From: Carrillo, Abiel X.
Sent: Tuesday, December 13, 2016 8:18 AM
To: 'Hiram Crook'; Diane Hoelzer
Cc: 'Tim Aldrich (tim.aldrich@comcast.net)'
Subject: RE: Puerta del Bosque - G12D035

PLAT
FOR
PUERTA del BOSQUE

RE: Puerta del Bosque
Grading and Drainage Plan
Stamp 12-2-2016 (File:G12D035)

Based on the information provided in your submittal received 11-1-2016, the above-referenced Grading and Drainage Plan cannot be approved for Preliminary Plat and ESC Grading Permit until the following items are addressed:

A16018_PLAT.dwg	Drawn: ACH	Checked: TA	Sheet 2 of 2
Scale: AS SHOWN	Date: 12/12/2016	Job: A16018

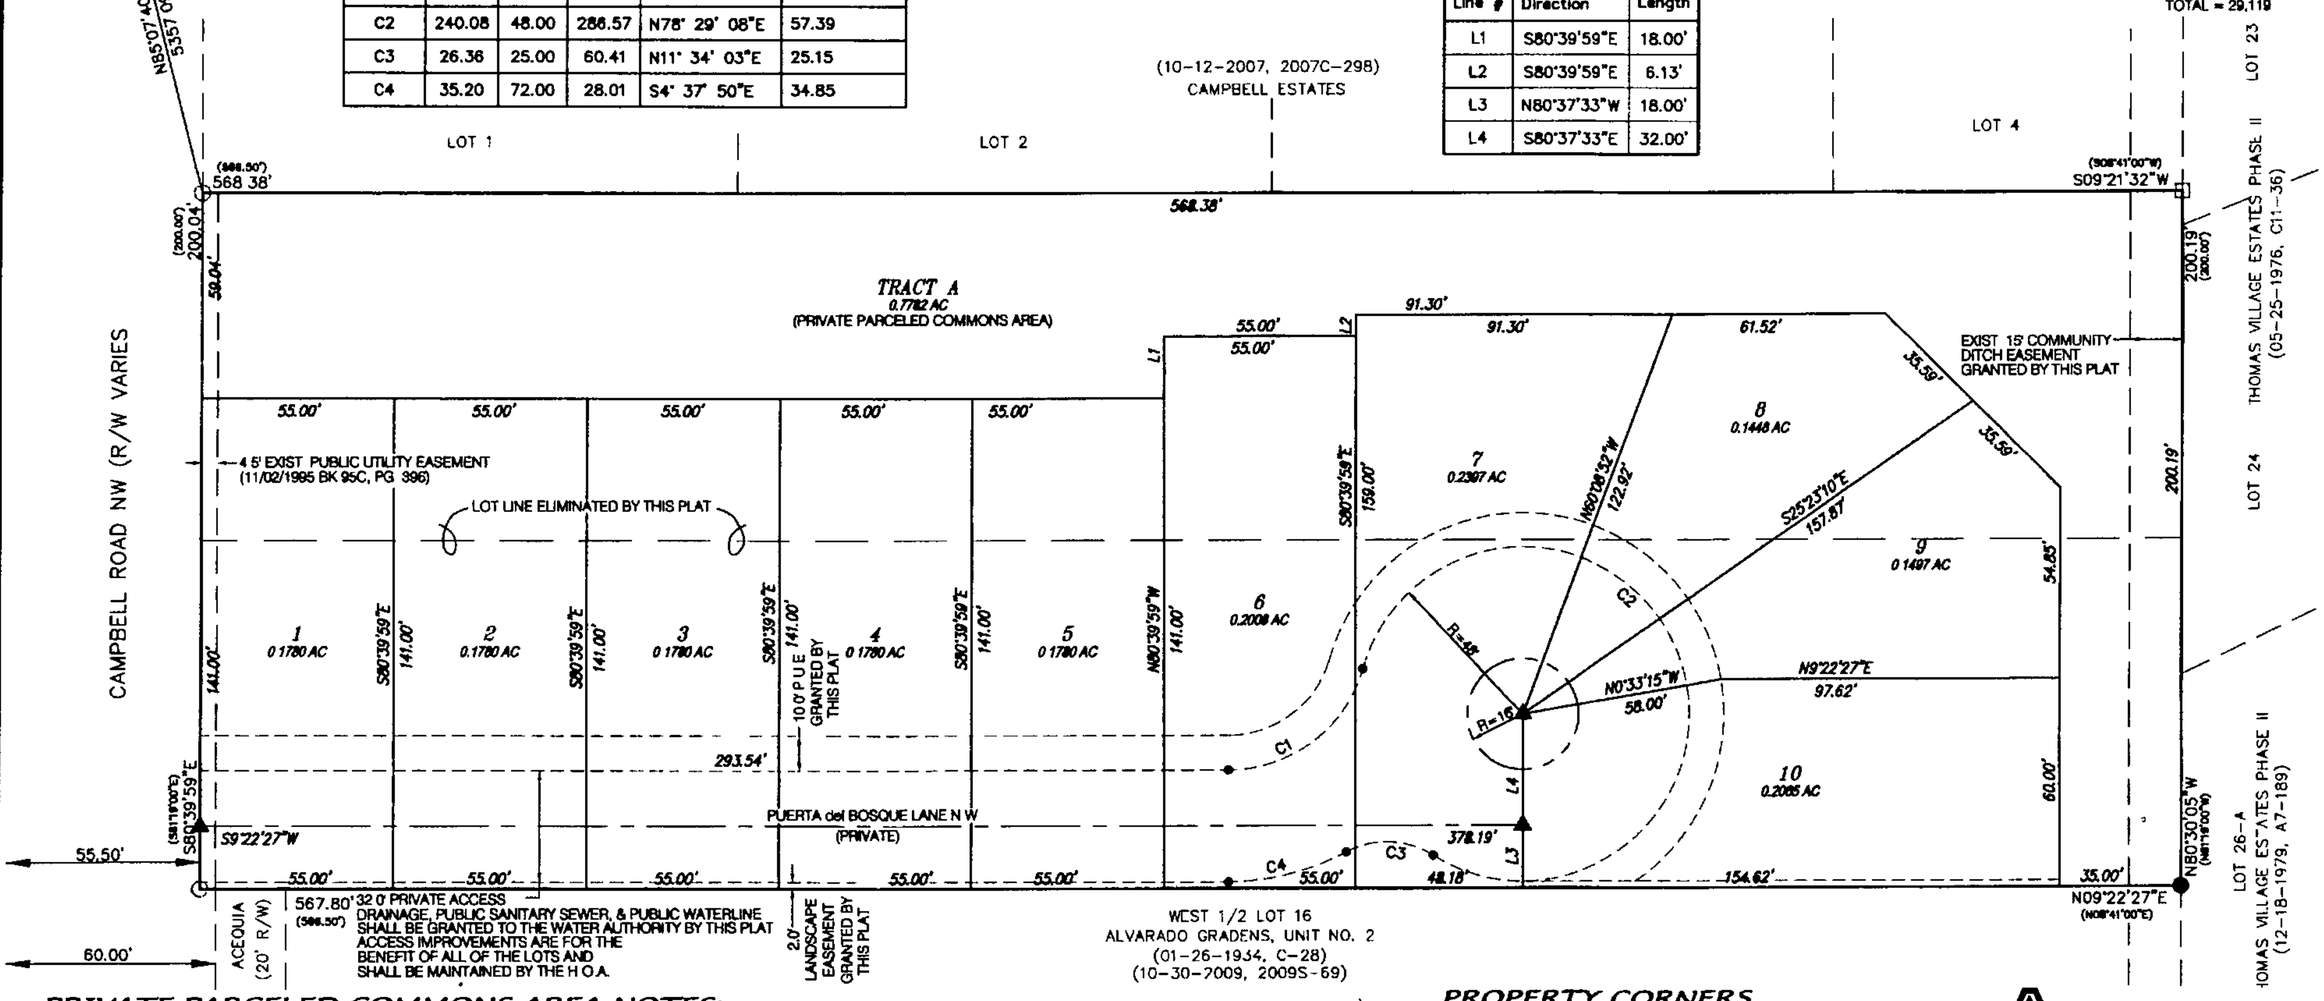
The way you have it is fine, I checked with Shahab and Jack. For final plat, however, he might bring up the fact that you'll need the covenants in place for the Private commons as described in the dpm. We might need the covenant to specifically mention the pond, since the PCA language in the DPM doesn't automatically assume that there is a pond in the PCA, if that makes sense...

The new note 4 looks fine, but delete note 5, the City would not have a reason to enter the property, and would not be tasked with taking over maintenance.

1. Note 4 on Sheet 2 of the Plat should not contain any references to City access for maintenance of the pond. The City does not maintain private facilities (anymore). So basically, delete everything after "Association;" in the first sentence.
2. Tract A is described as a recreational facility, but you should have an easement over the pond, or you can clarify in Note 4 that the deeding of Tract 4 is for the maintenance of the pond by the HOA (the tract is already described as maintained by the HOA, but not specifically for the pond).

Attached is a pdf of the changes to the notes 4 and 5 as we spoke on the phone. As stated in our phone conversation, we want to make sure that note 5 is not need as Jack Cloud before requested it. Please let us know if this is adequate for approval on Wednesday.

Can you check the attached revised Plat, sheet 2. I made changes in response to your comments below. If it is acceptable I will make copies Monday and resubmit to DRB staff, and bring revised sheet to DRB on Wednesday.

I revised Note 4 and renumbered 5 and 6.
